Access Compliance Report

Public Rights-of-Way

(Curb Ramps)

Intersection ID: 2491	Main Street: LYNNEWOOD_GLEN_DR	Cross Street: MCCCHESNEY_DR	Location: S
ADA ID: 60C8427B9756	Ramp Type: BlendTrans1	Initial Pass/Fail: Pass	Overall Compliance: No
Codes/Mitigation Info/Possible Solution		Field Measurements/Component Compliance

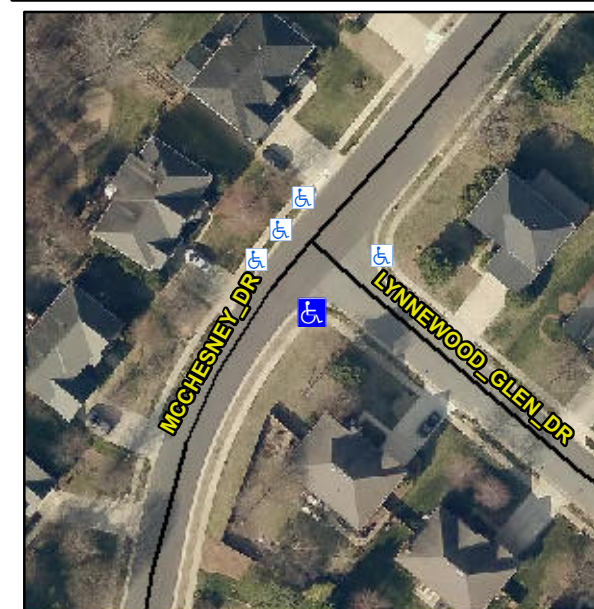
R304.5.3, R305

Compliance	Description	Data	Compliance	Description	Data
N/A	Ramp Length (in)	48.0	Yes	BlendTrans Slope (%)	4.0
Yes	Ramp Width (in)	48.0	No	BlendTrans XSlope (%)	4.0
N/A	Flare Type LT	Sloped	N/A	Flare Type RT	Sloped
N/A	Flare Slope LT (%)	5.3	N/A	Flare Slope RT (%)	4.0
N/A	Flare Traversable LT?	No	N/A	Flare Traversable RT?	No
Yes	Landing Length (in)	49.0	No	DWS Provided?	No
Yes	Landing Width (in)	48.0	N/A	DWS Contrast?	No
Yes	Landing Slope (%)	1.6	N/A	DWS Length (in)	N/A
No	Landing X Slope (%)	2.1	N/A	DWS Full Width?	No
N/A	Landing Curb? (Y/N)	No	N/A	DWS Offset (in)	N/A
N/A	Shared Landing?	No			
Yes	Gutter Ponding?	No	Yes	Gutter Slope (%)	1.4
Yes	Gutter Lip Ht (in)	0.0	Yes	Gutter X Slope (%)	0.3
N/A	Painted X Walk1?	No	N/A	Painted X Walk2?	No
	X Walk 1 Direction	To NE		X Walk 2 Direction	To NW
	X Walk 1 Width (in)	N/A		X Walk 2 Width (in)	N/A
	X Walk 1 Slope (%)	1.1		X Walk 2 Slope (%)	2.4
	X Walk 1 X Slope (%)	1.7		X Walk 2 X Slope (%)	1.7

Remove & Replace Curb Ramp With Two New Directional Ramps or Equivalent.
